Appeal Decision

Appeal Ref: APP/R5510/W/23/3318219

104 Windsor Avenue, Uxbridge, Hillingdon UB10 9BA

Development: Erection of a 3-bedroom house including 2 x dropped kerb, cycle and bin storage and ev charging point

LOFT

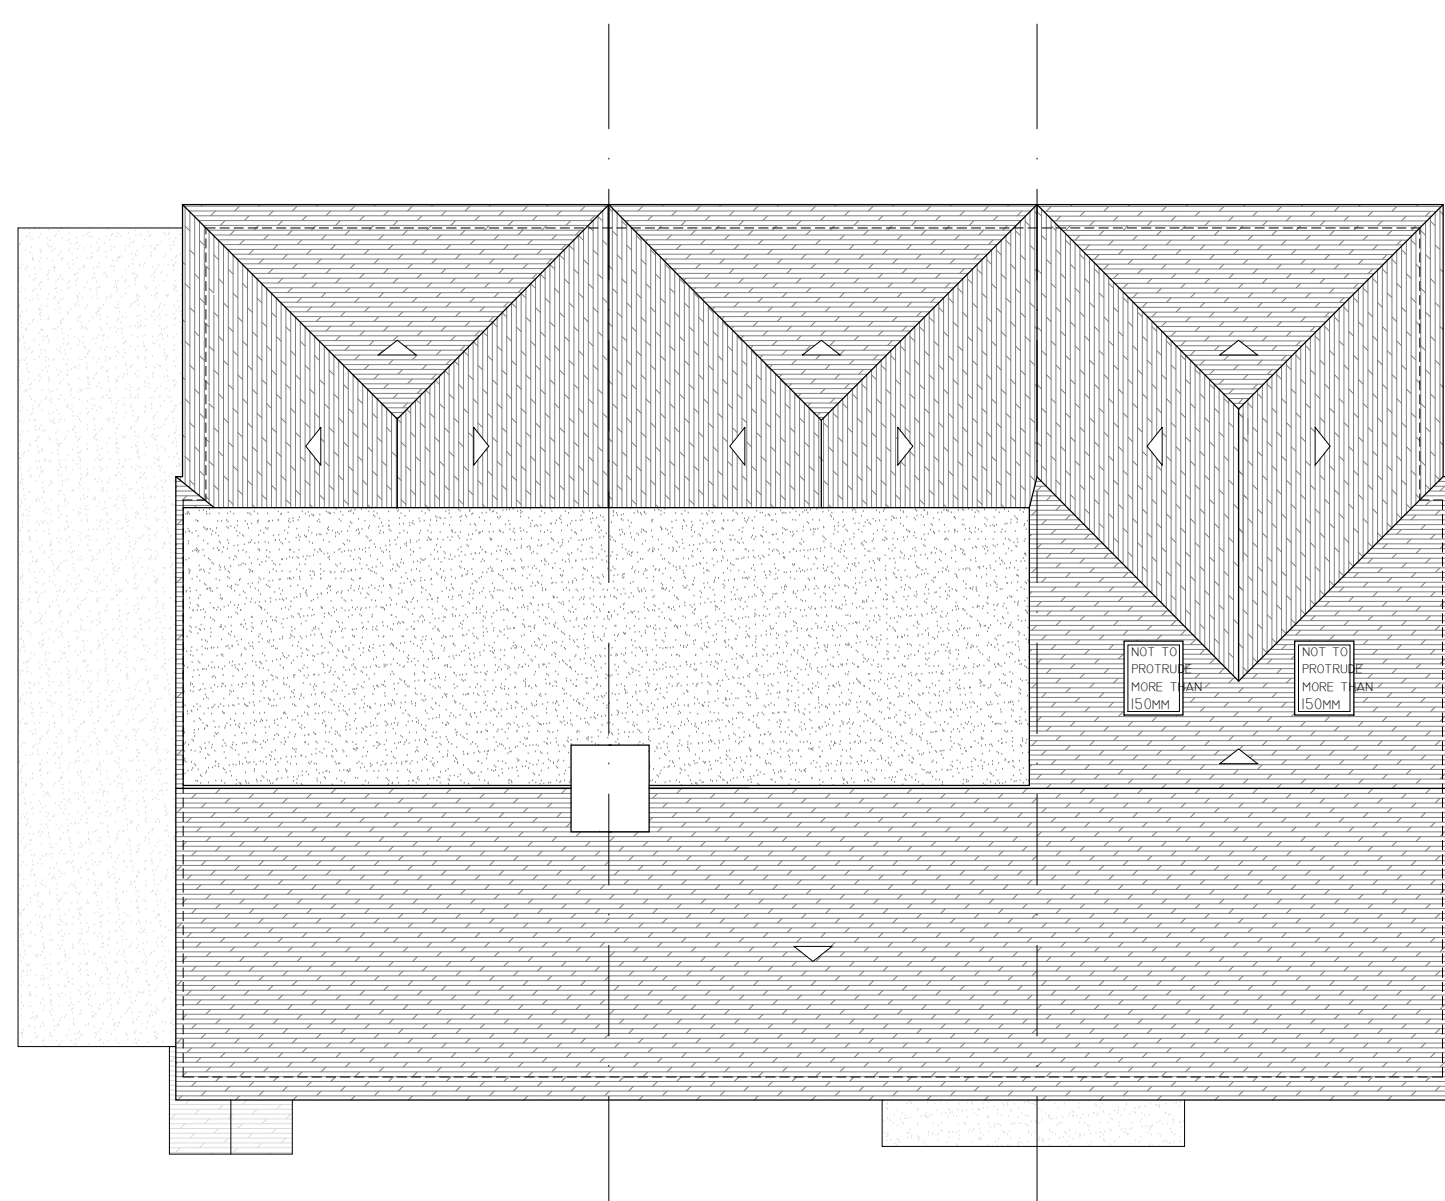
8. The proposal includes a bedroom on the second floor which would be solely lit with rooflights. The rooflights appear to be of sufficient size to provide light to the room and due to their height and position within the roof they would provide sufficient outlook for the occupiers of the proposed dwelling, particularly the second-floor bedroom.
9. I conclude that the proposal would provide satisfactory living conditions of the future occupiers of the dwelling with particular regard to outlook. It would not conflict with Policy D6 of the LP and Policies DMHB 11 and DMHB 16 of the HLP which together, amongst other matters, seek to ensure that development is of high-quality design and meets the occupiers' needs.

The proposed layout which includes a bedroom at roof level served only by rooflights, would fail to provide an adequate source of outlook resulting in poor quality and substandard accommodation for future occupiers of the dwelling. The proposal is therefore contrary to Policy DMHB 11 and 16 of the Hillingdon Local Plan: Part Two - Development Management Policies (January 2020) as well as Policy D6 of the London Plan (2021).

The previous reason for refusal (no.2) relating to the ground floor study and bedroom at roof level "failing to provide an adequate source of outlook resulting in poor quality and substandard accommodation for future occupiers of the dwelling", has been overcome by the study being removed from the plans. However, the third bedroom continues to be served only by rooflights which provide limited outlook for future occupiers. The quality of living accommodation for future occupiers would still be unacceptable.
